5. CASE 22. 092, 171 CONGDON STREET, Ephraim Martin House, 1856 (COLLEGE HILL)

Project: Three Family Residence  
Address: 171 Congdon Street, Providence, RI 02906  
Date: 18 August 2022 - Revised  
Re: Application Information

## **NARRATIVE – Scope of Work**

WINDOW ELEVATIONS

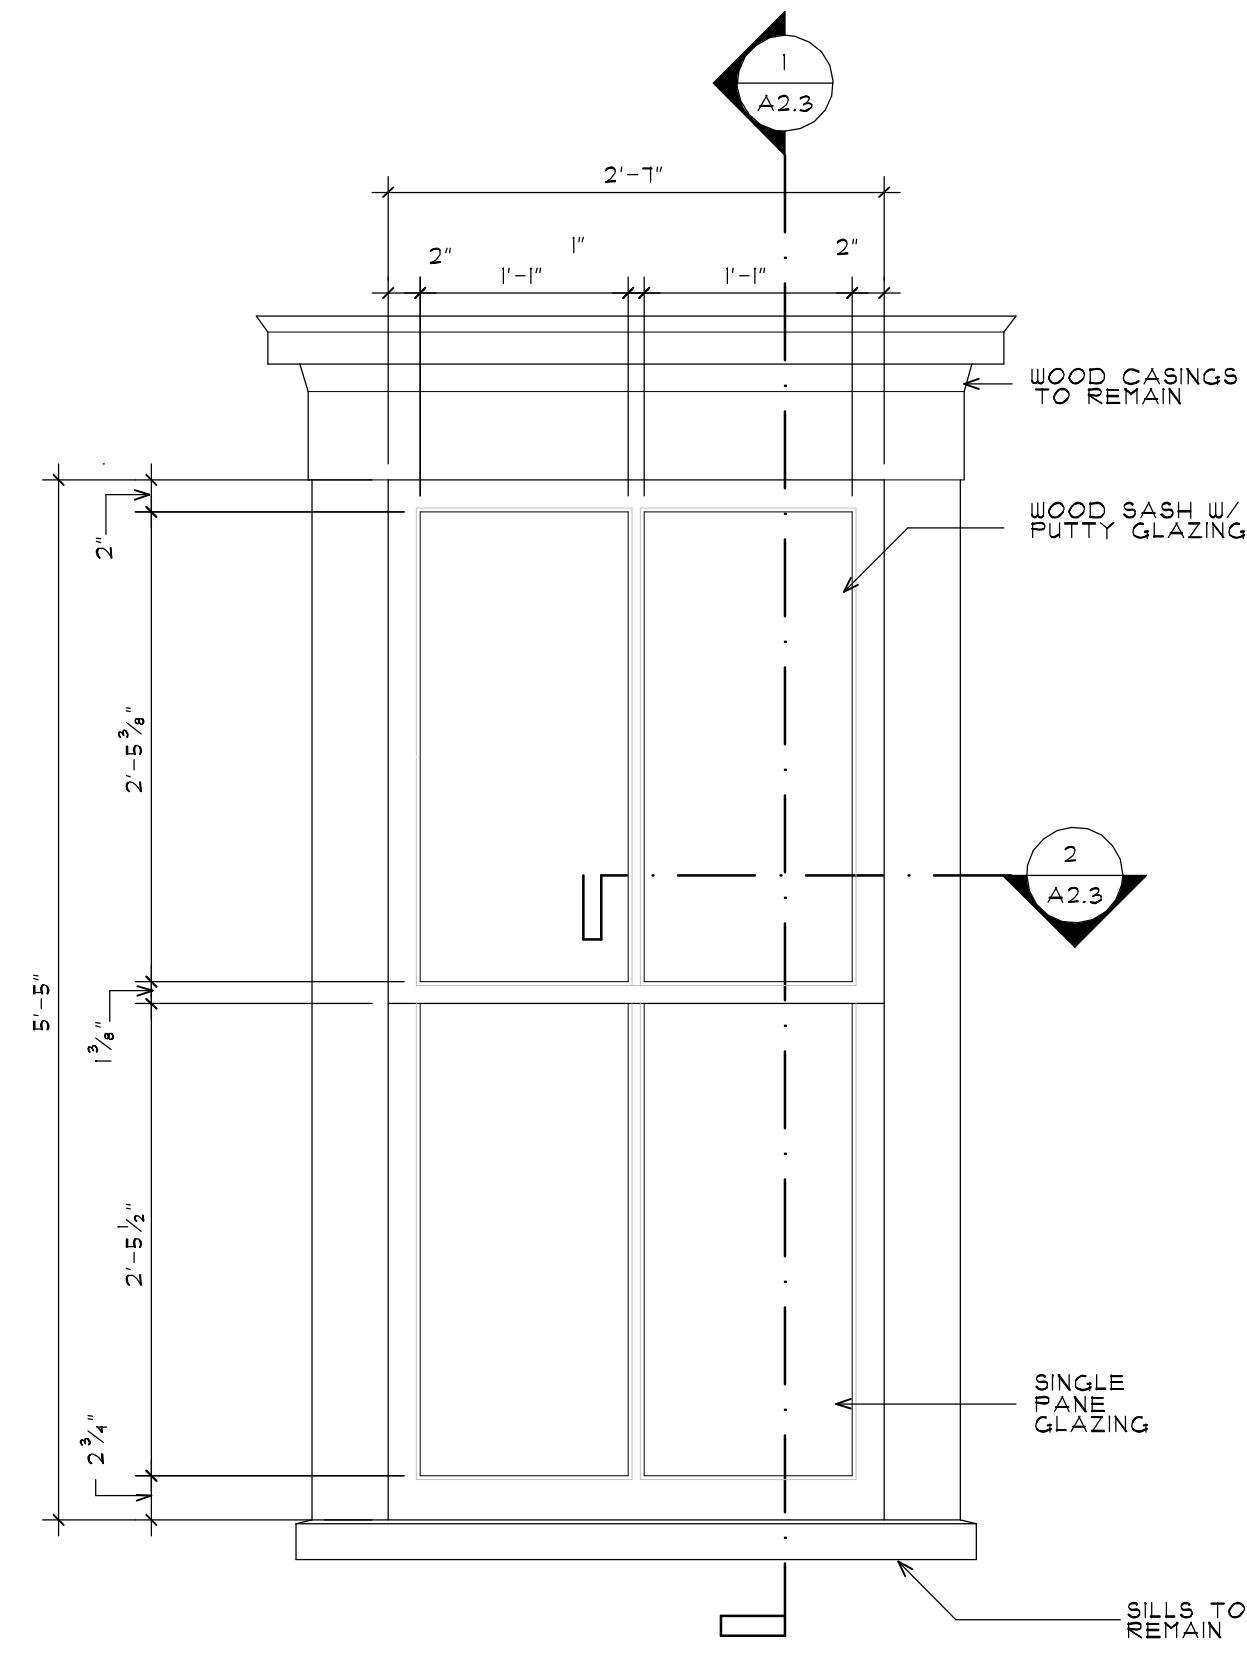
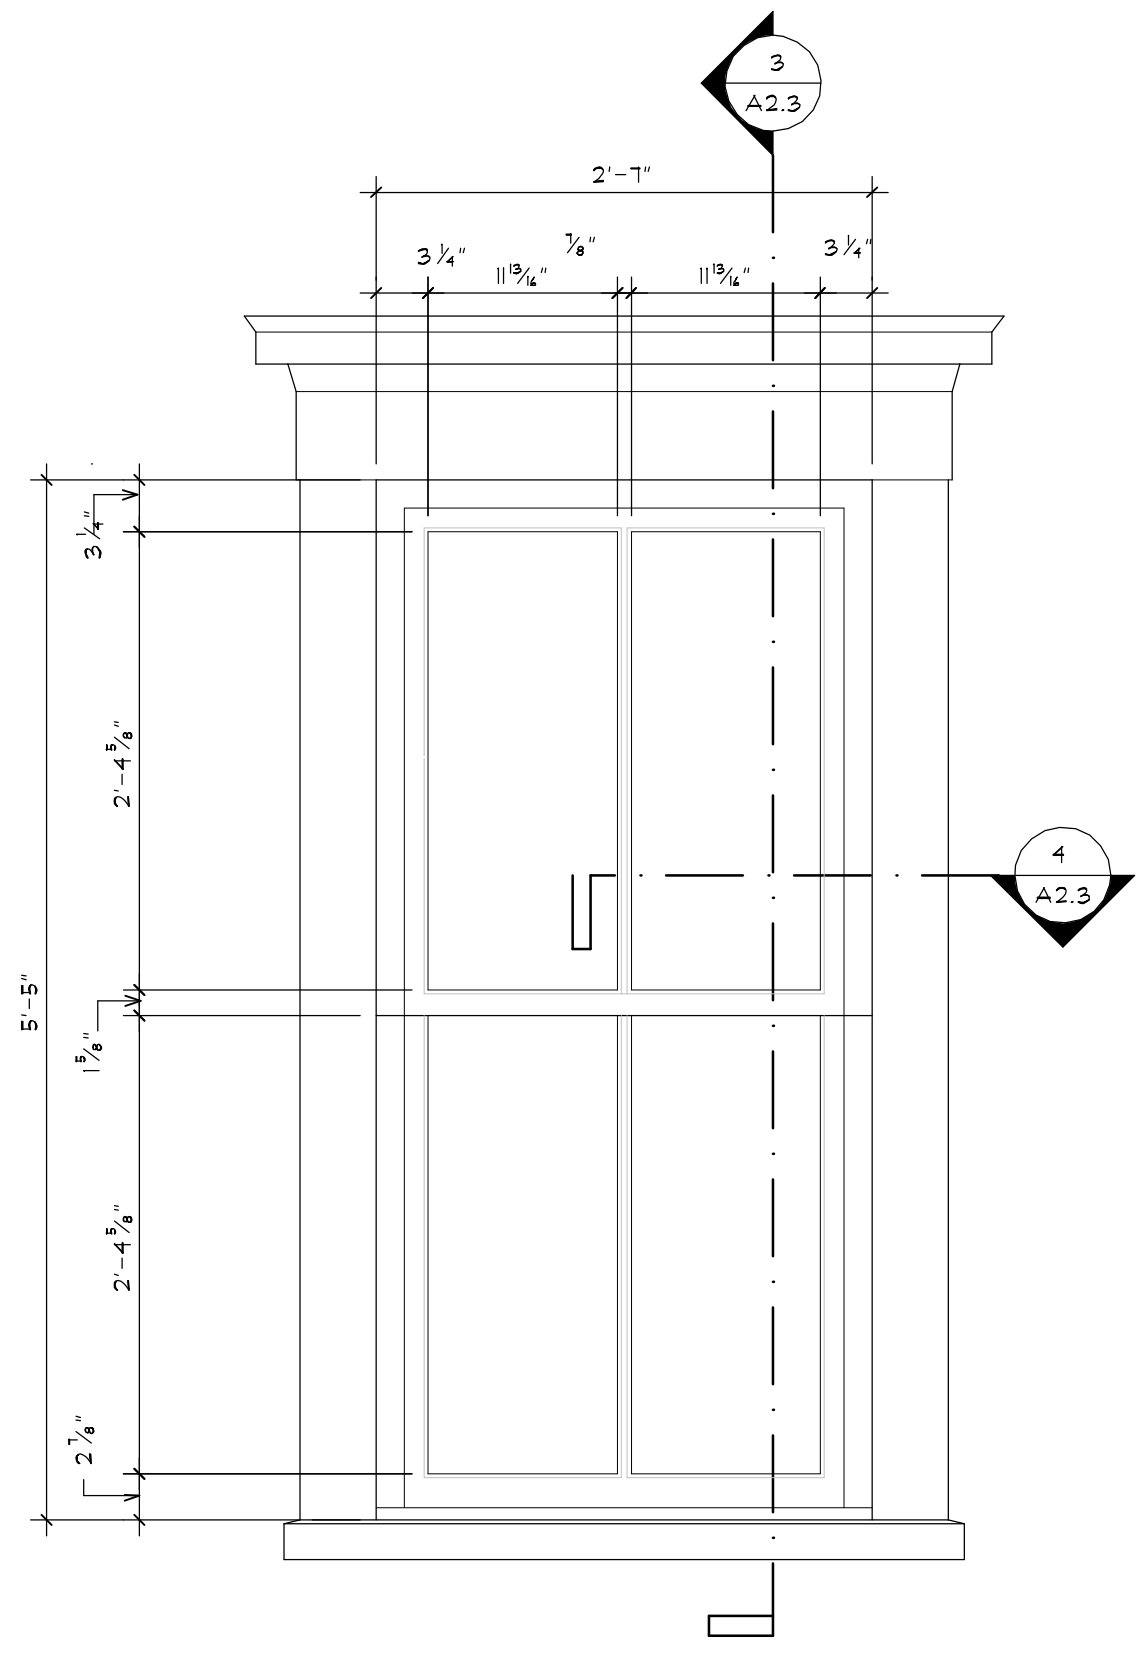
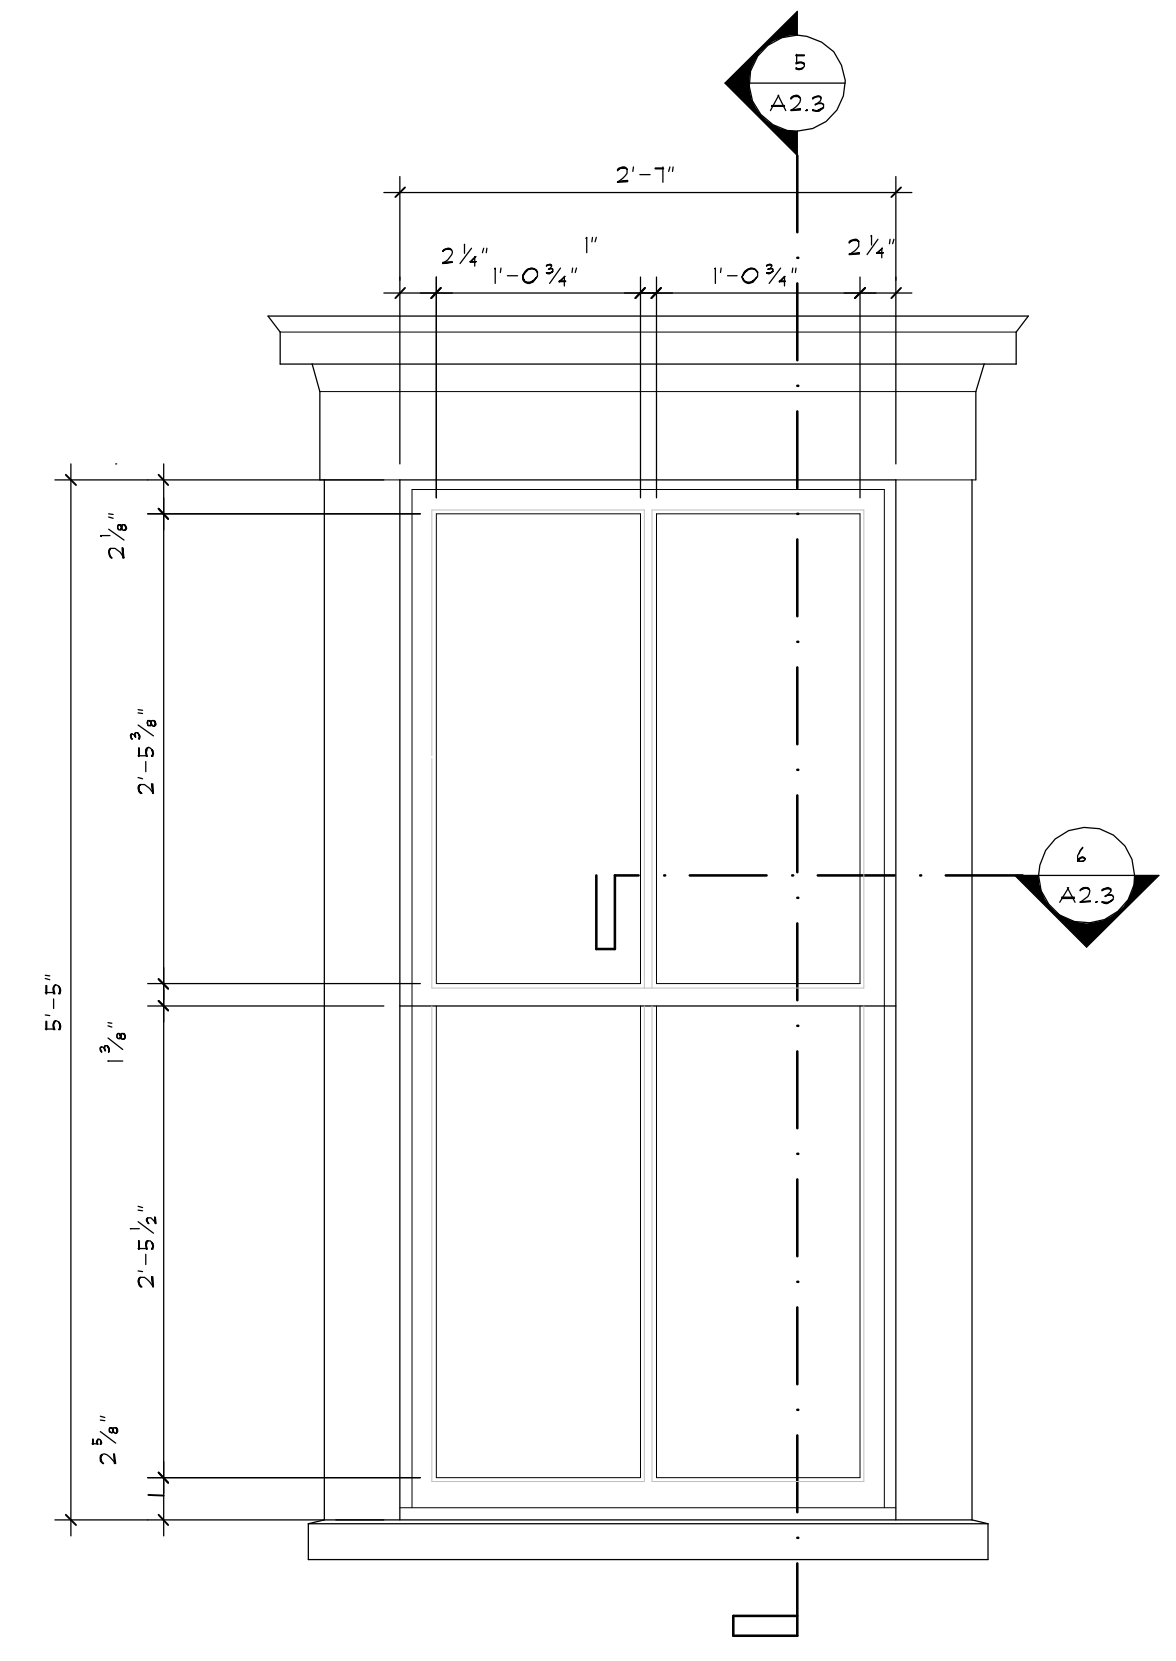
- Aesthetics – The Owner is willing to install new windows which are similar to the existing. The muntin size and spacing will be matched. The difference in glass area reduction is 12% for unit “A”. From the exterior, the new sashes, along with removal of the storm windows, will result in windows which are close to the original in size, function, appearance and profile depth with windows within the wall plane, which is diminished by the storm windows.
